**Texas Department of Transportation
Book 2 - Technical Provisions**

**North Tarrant Express Project
Segments 3A and 3B Facility**

**Attachment 11-1
Approved Design Deviations**

September 30, 2012

35WSchdc.prof.pdf

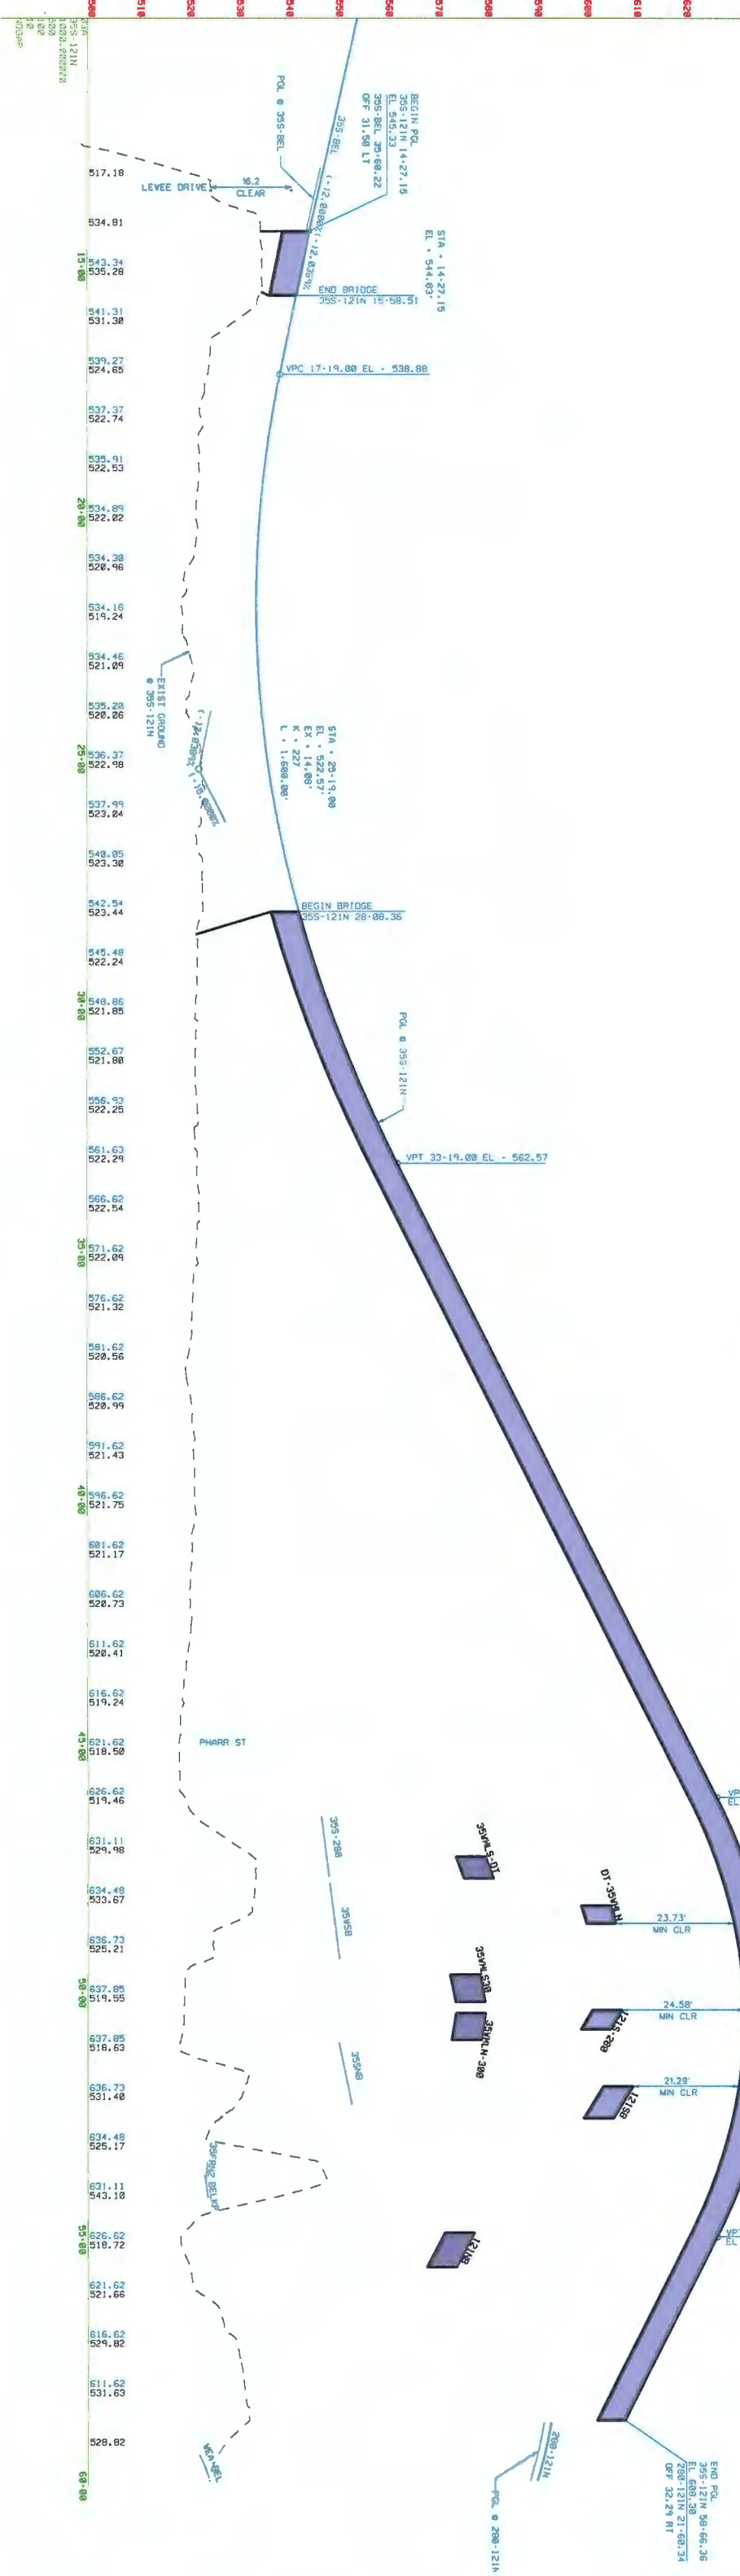
REVISED
TO ADD 1 LEVEL
TO INTERCHANGE

REF 24
Ms. 1
From profile in
email

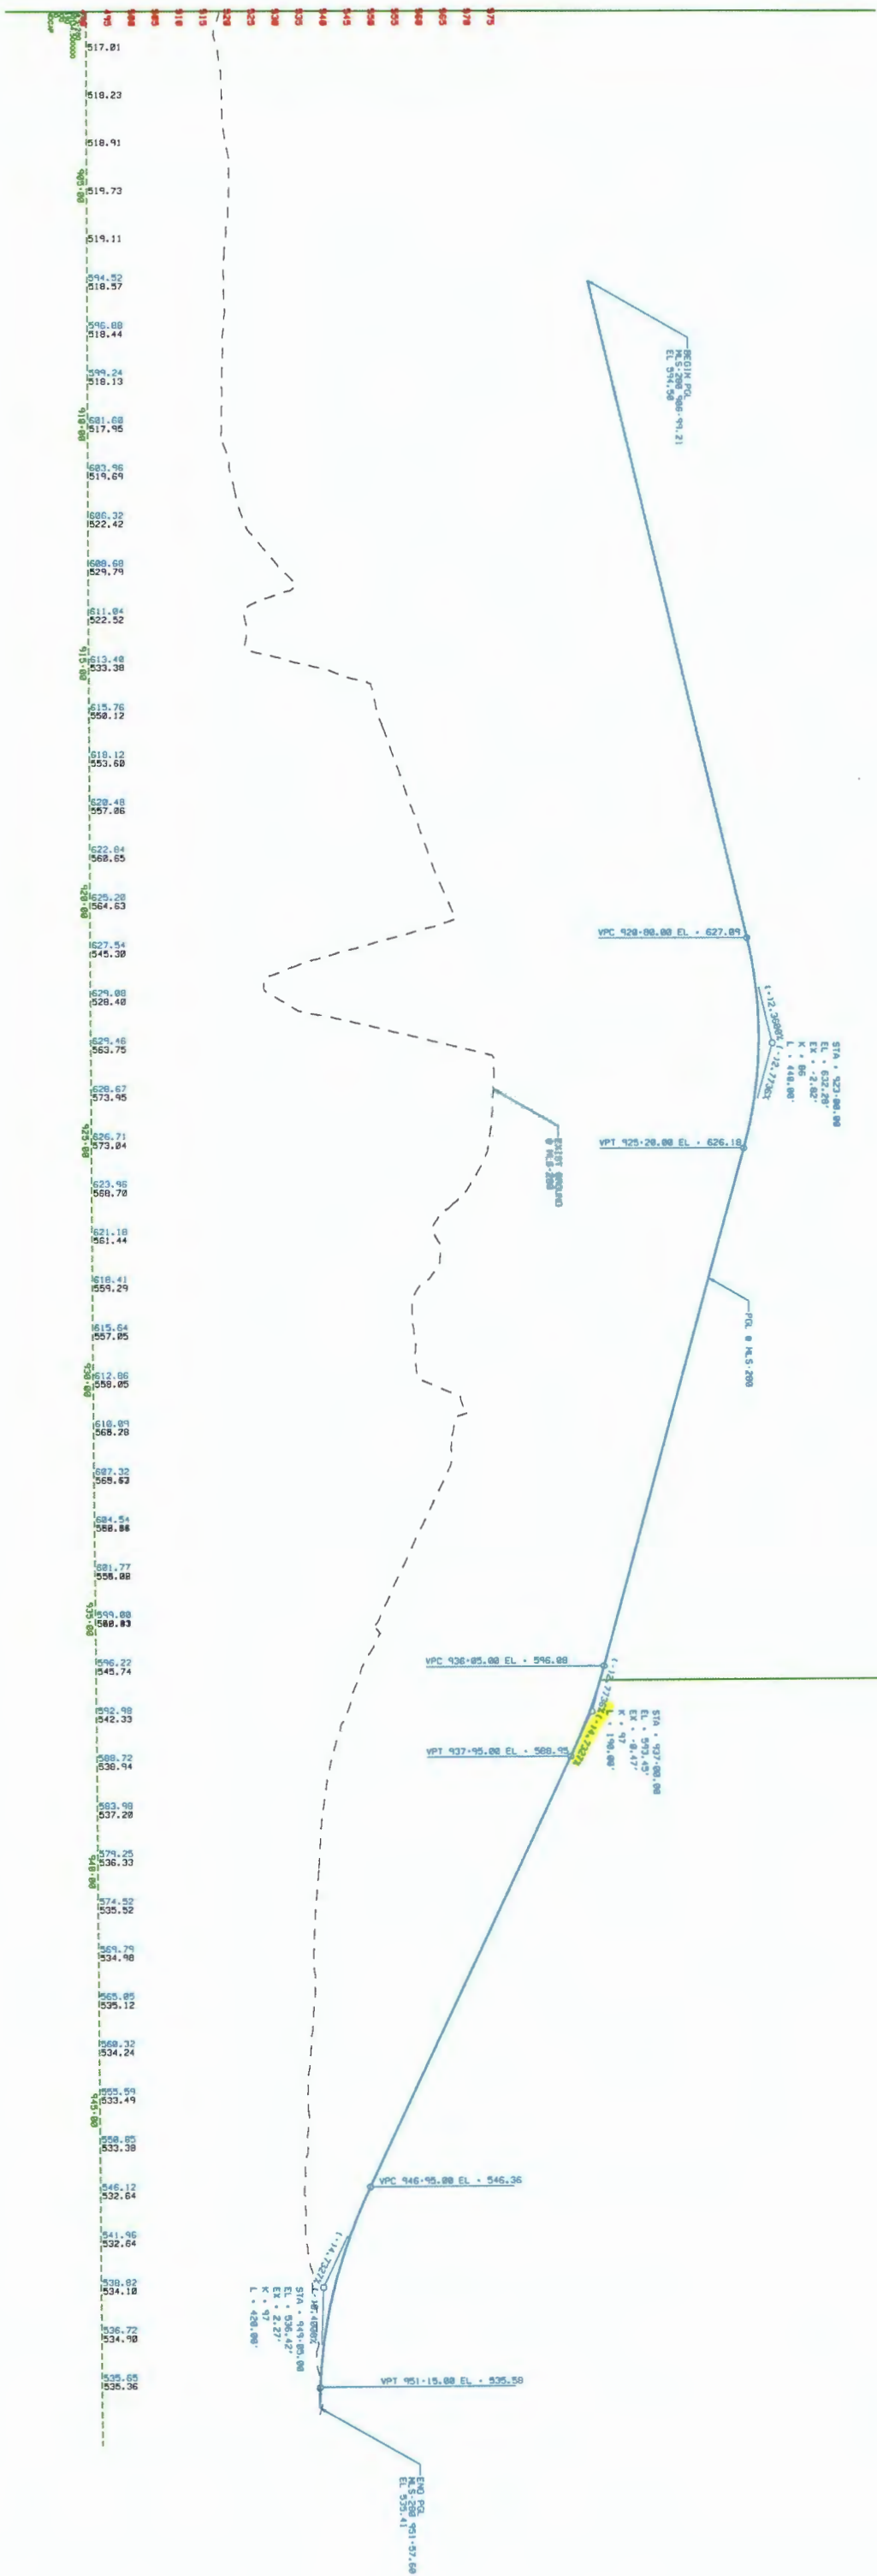
REI No 2A
 No. 2
 Show BRIDGES
 STRUCTURE DEPTH ETC
 SHOW EXIST PAV BRIDGUE

REVISE "K" VALUES
 ADJUST LIMITS TO
 BRING GRADE $\leq 4\%$

HORZ.: 1" = 200' SHEET 5 OF 15

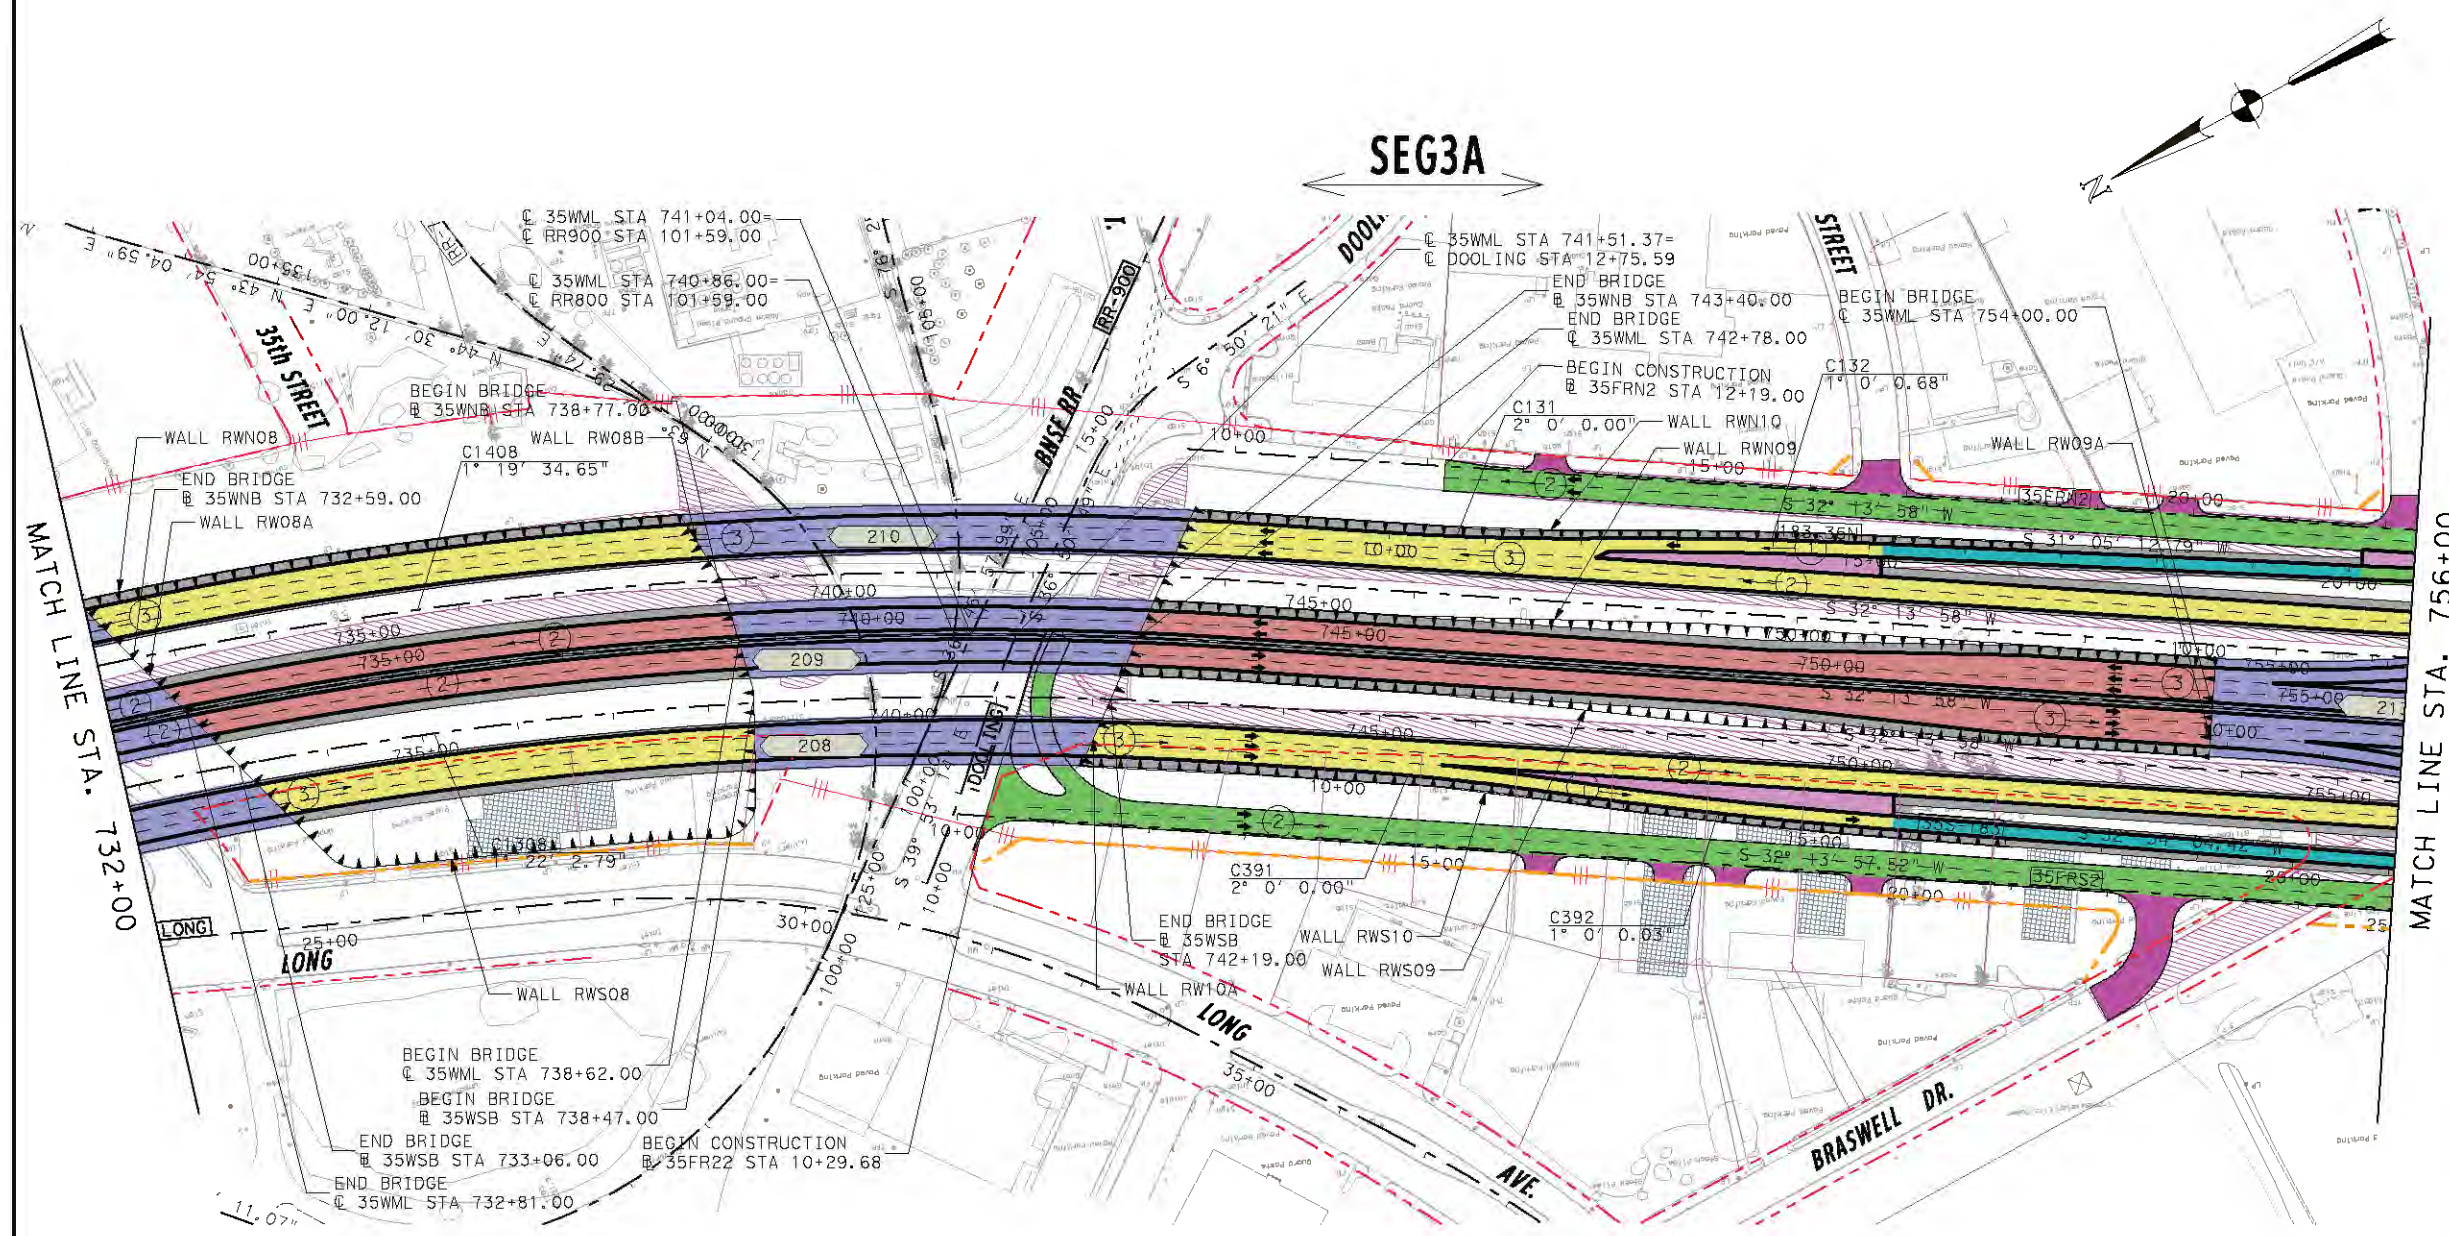
NOTE: CURVE 35WML-4 SHALL COMPLY WITH AN SSD OF 60 MPH AS REQUIRED BY THE NORTH TARRANT EXPRESS MDP CDA GEOMETRIC DESIGN CRITERIA NOTE 12.
